FILE CSSTP-0006-00(049),
Cobb & Paulding Counties
SR 360 FM SR 176/COBB TO
SR 120/PAULDING
P.I. No. 0006049

SUBJECT **Request for VE Reversal**

RE: **VE Study Reversal**
CSSTP-0006-00(049), Cobb/Paulding Counties
PI No. 0006049
SR 360 From SR 176/New Macland Rd to SR 120/Paulding

PI No. 0006049
SR 360 from SR 120 to SR 176
Paulding and Cobb Counties
Request for VE reversal

~ Sta 31+00 LT, Parcels 10 & 13

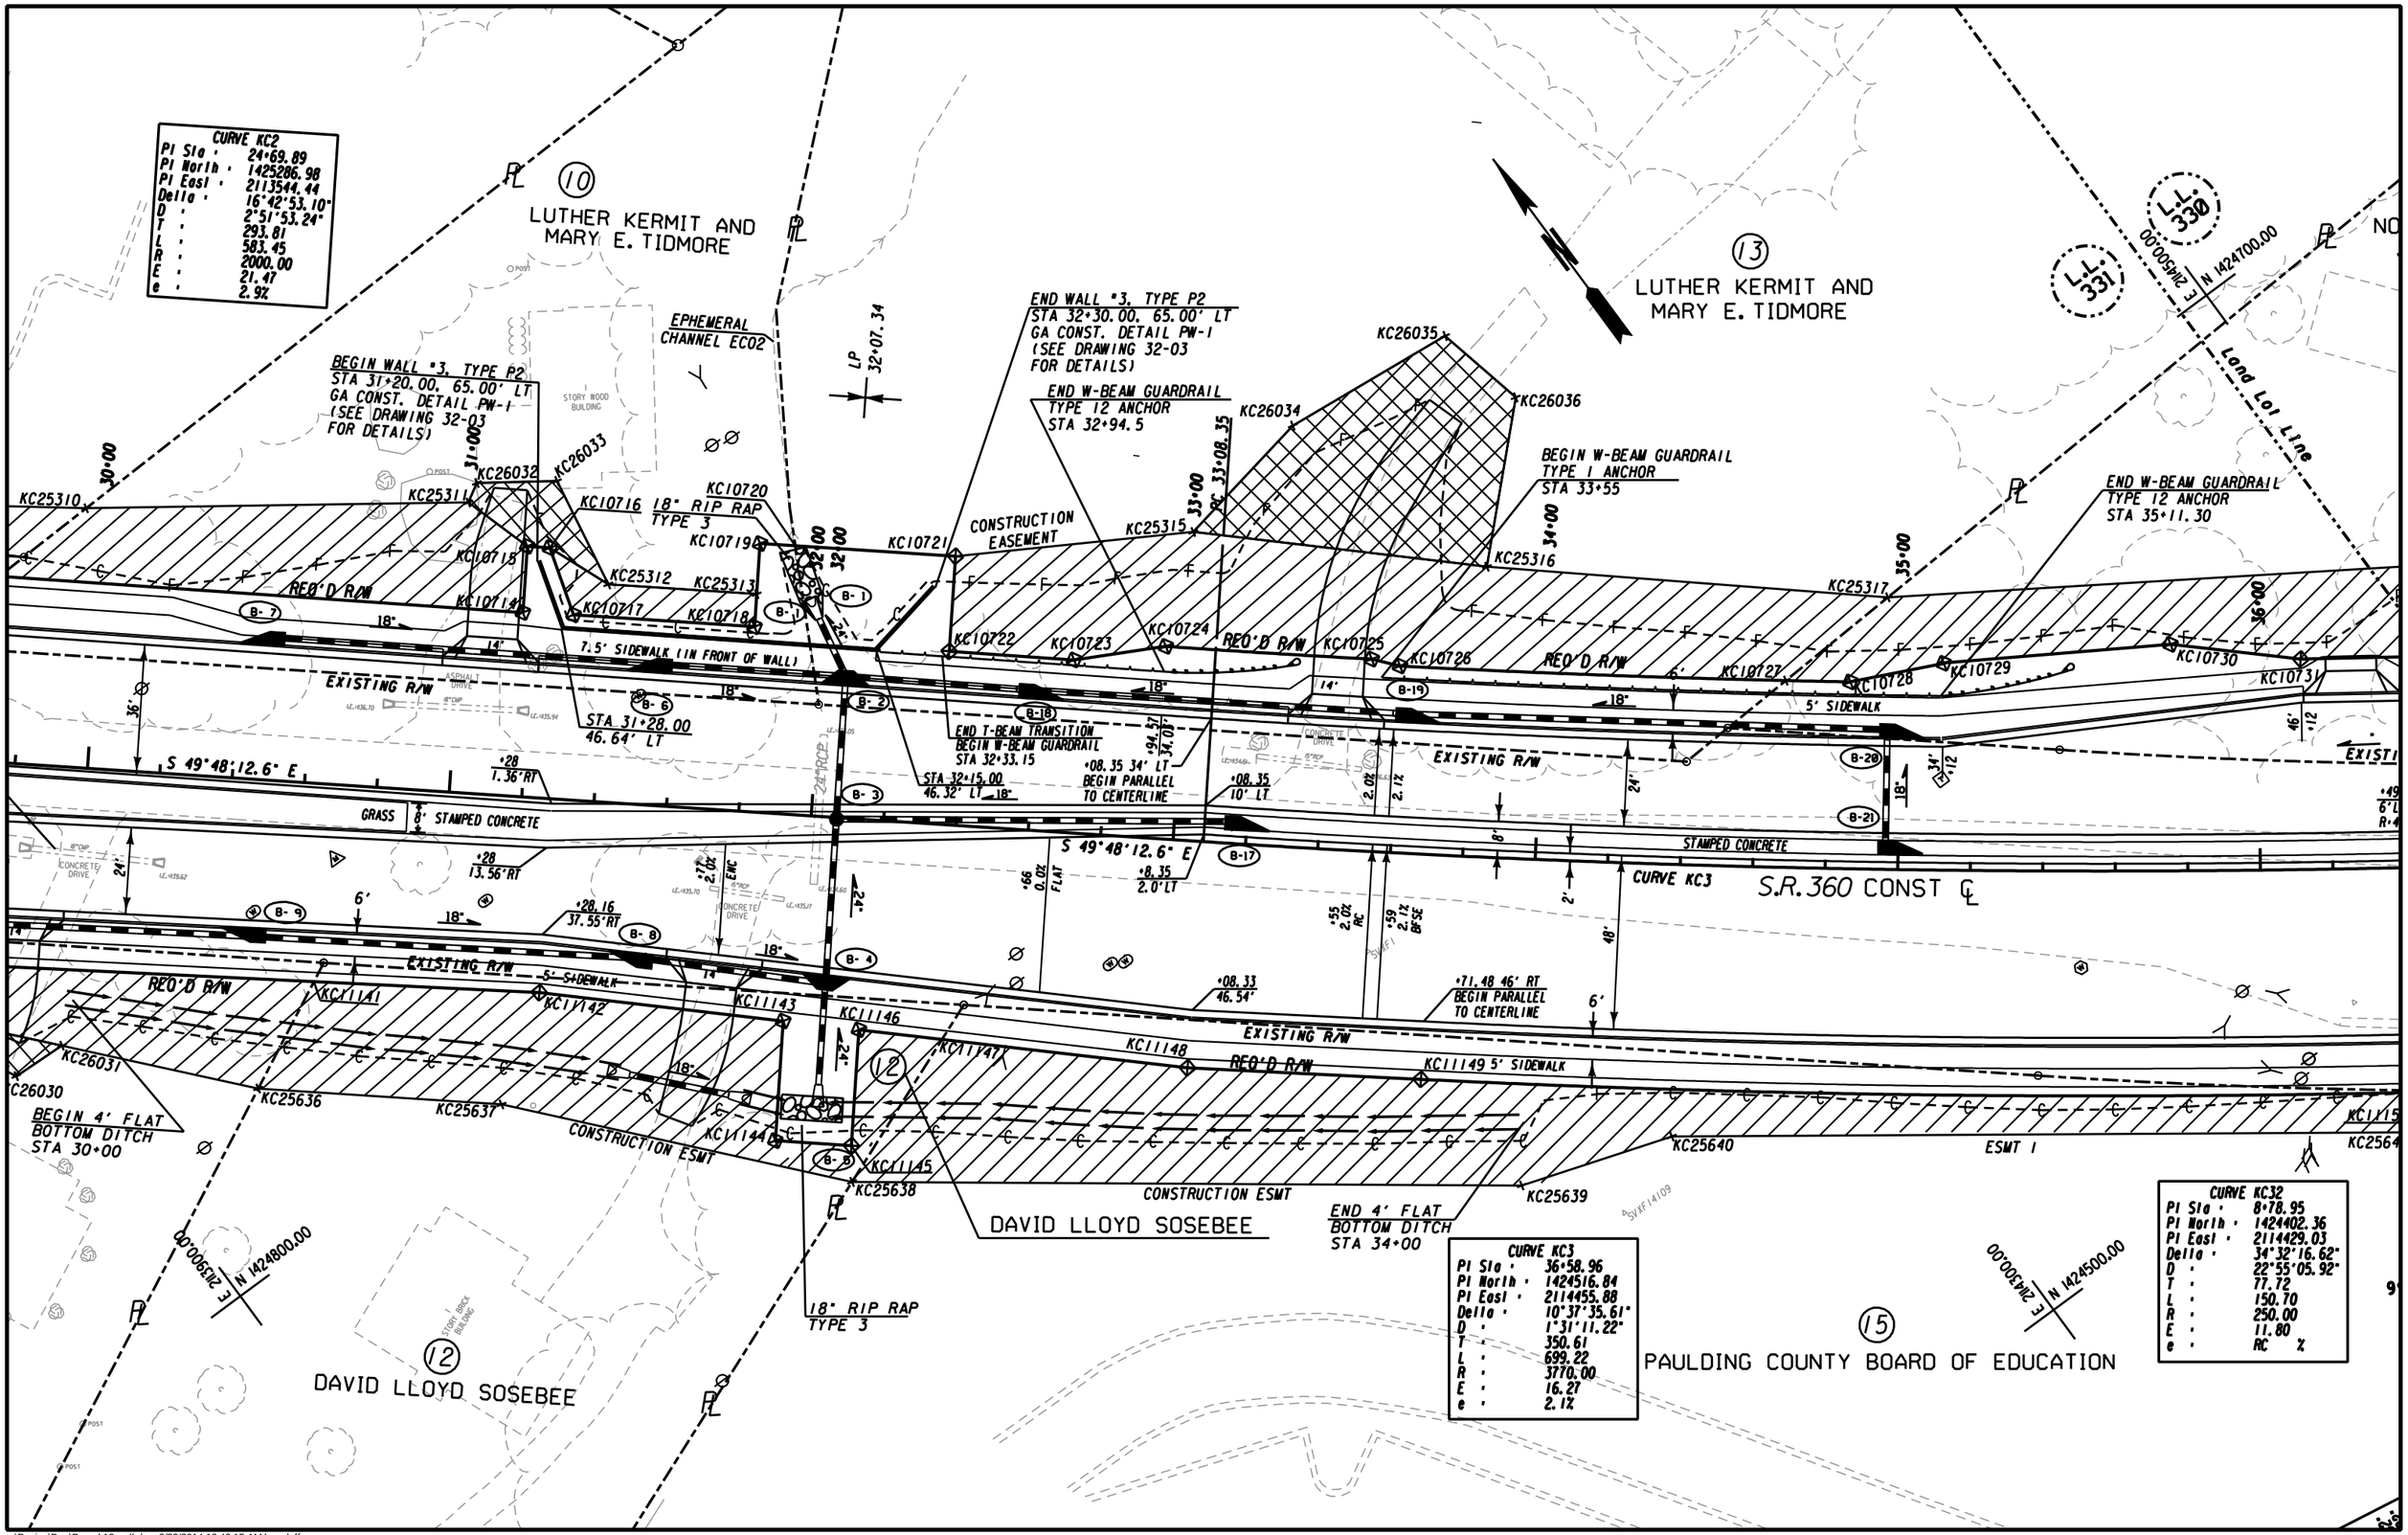
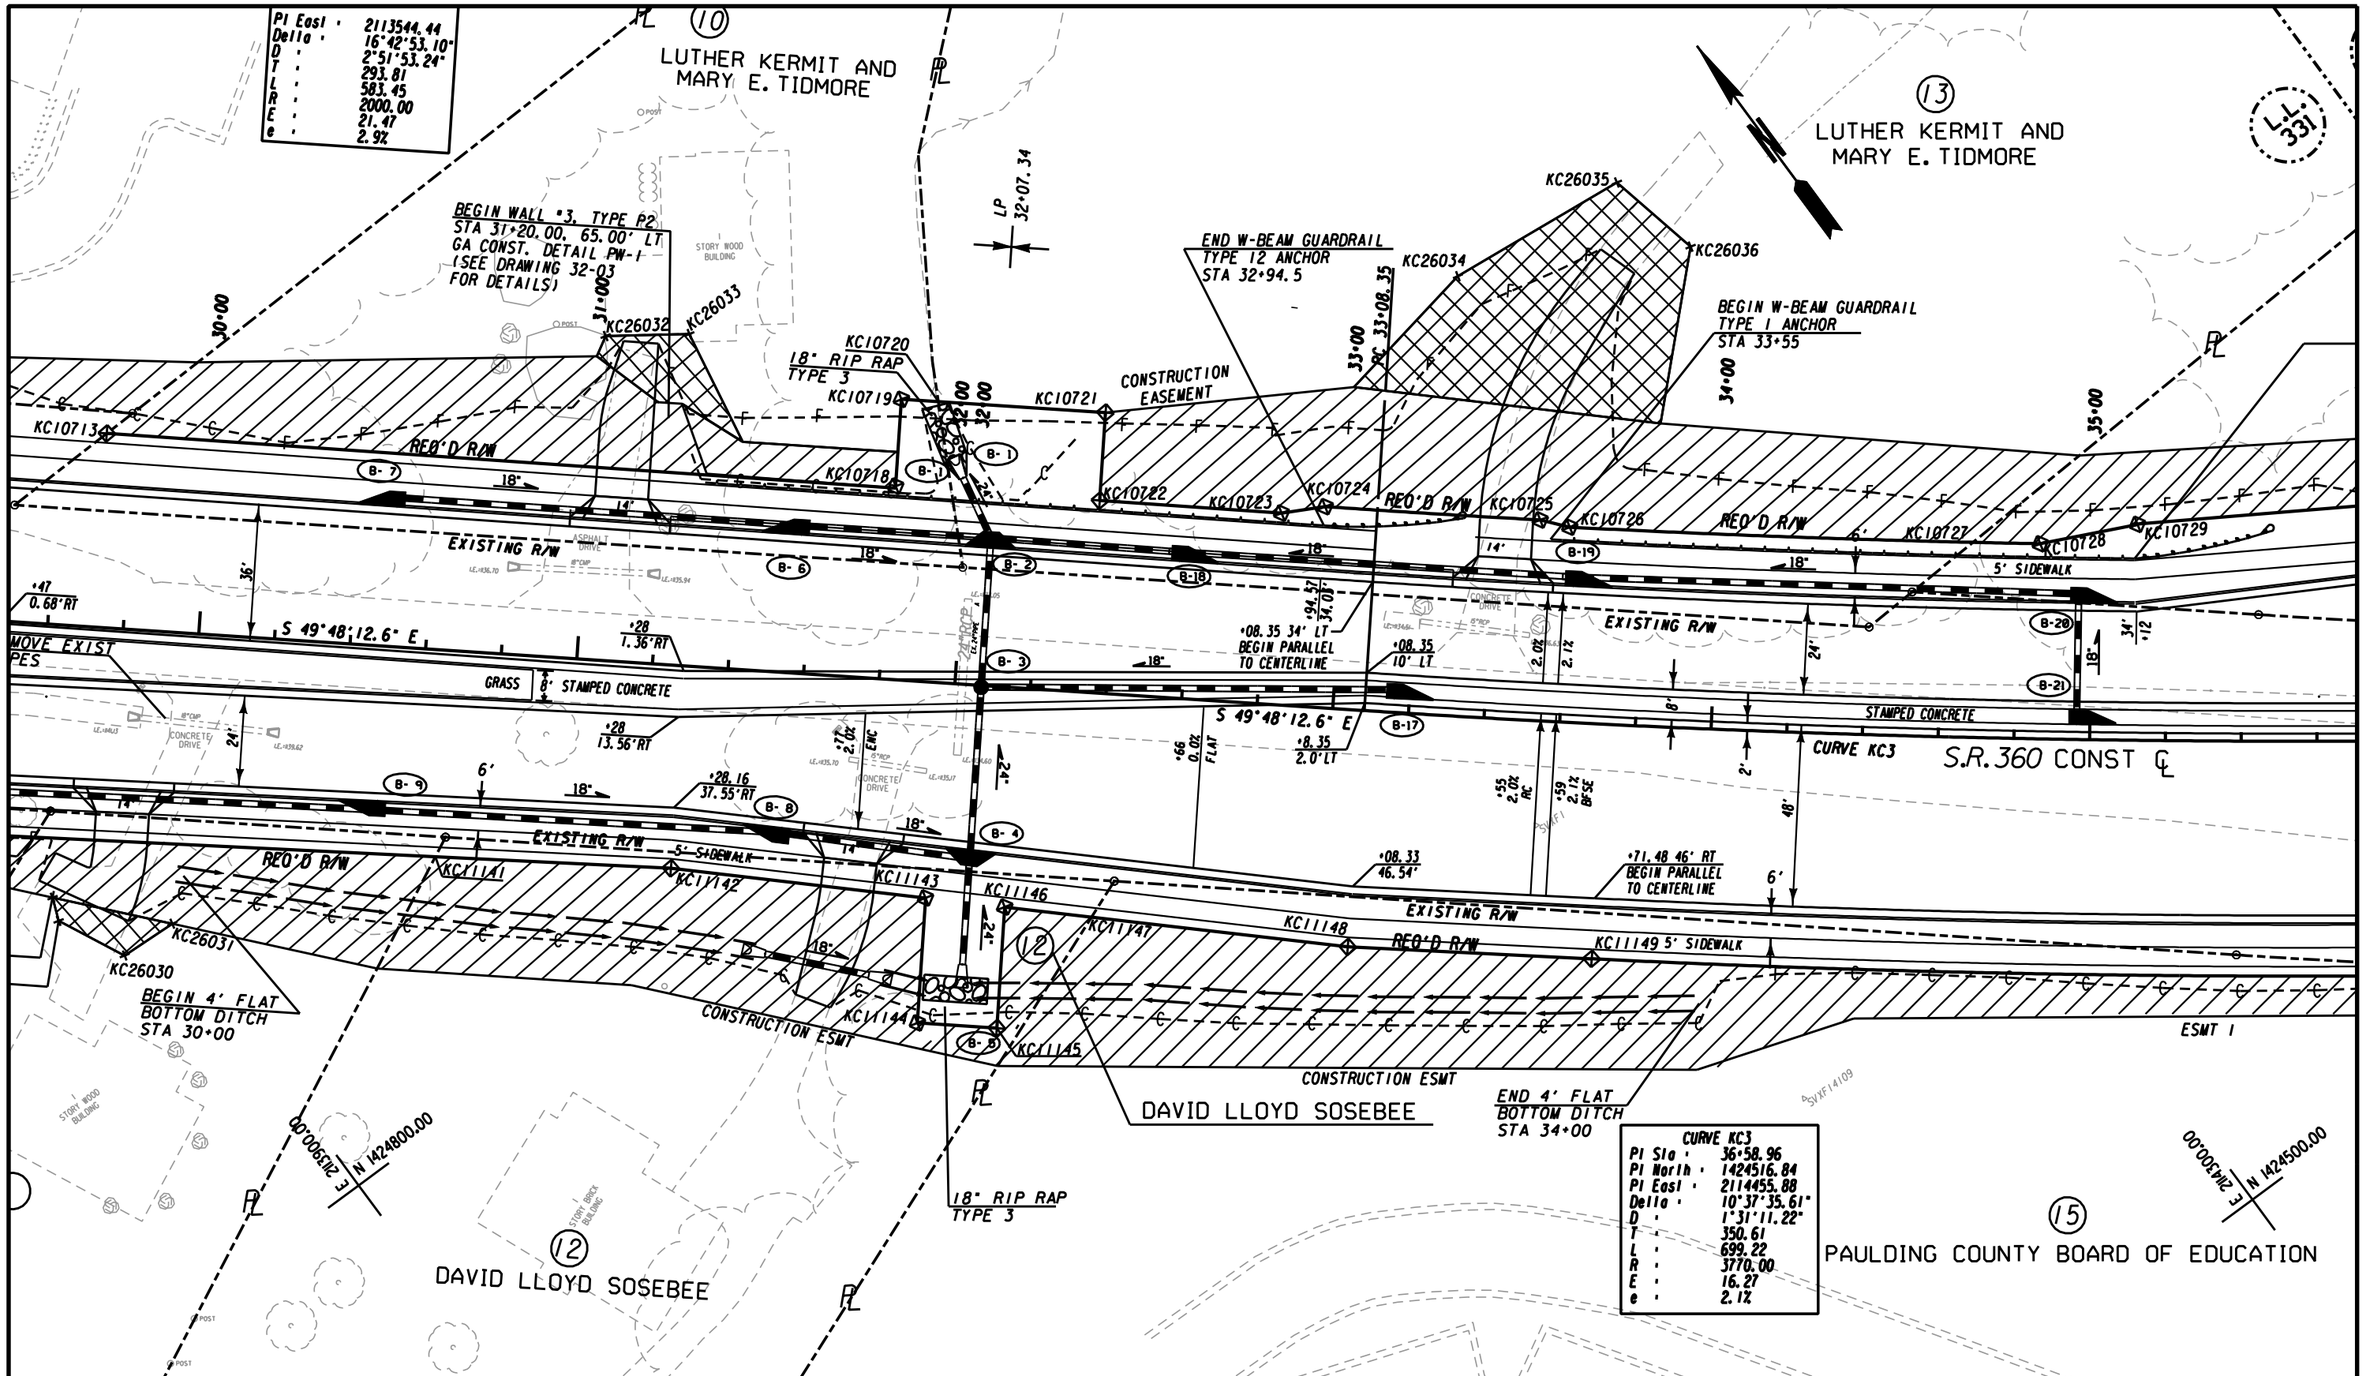
Since the VE study was completed, all four walls have been fully designed and incorporated into the plans. Subsequently, two of the walls have been re-analyzed and reviewed, and determined that it would be a reduction in project cost to remove the walls. (~sta 31+00 Lt Parcels 10/13, and ~sta 60+00 Lt Parcel 41 (Holcomb) This has been fully coordinated the District 7 RW Office and through the RW negotiation process. Costs have been confirmed accordingly.

It is recommended to remove walls:

- ~sta 31+00 Lt Parcels 10/13
- ~sta 60+00 Lt Parcel 41 (Holcomb)

Without wall			With wall		
Item	units	no of units	Cost/unit	Total	no of units	Cost/unit	Total
embankment (negligable)							
Retaining Wall (P2)	lf	0			77	$450	$34,650
Retaining Wall (P3)	lf	0			35	$590	$20,650
T-beam Guardrail	lf	0		$0	18	$46	$828
W-beam Guardrail	lf	150	$16	$2,400	61	$16	$976
type 12 anchor	ea	1	$1,970	$1,970	1	$1,970	$1,970
type 1 anchor	ea	1	$680	$680	0		
E&C (10%)				$505			$5,907
RW cost	sq ft	4902	$2.50	$12,255	7368	$2.50	$18,420
Easement Cost	sq ft	9029	$1.25	$11,286	5384	$1.25	$6,730
Proximity of slope loss of value (RW and esmt areas calculated from station 30+00 to 33+00)	ea			$25,000	0		$0
TOTAL				$54,096			$90,131

difference
= $36,035
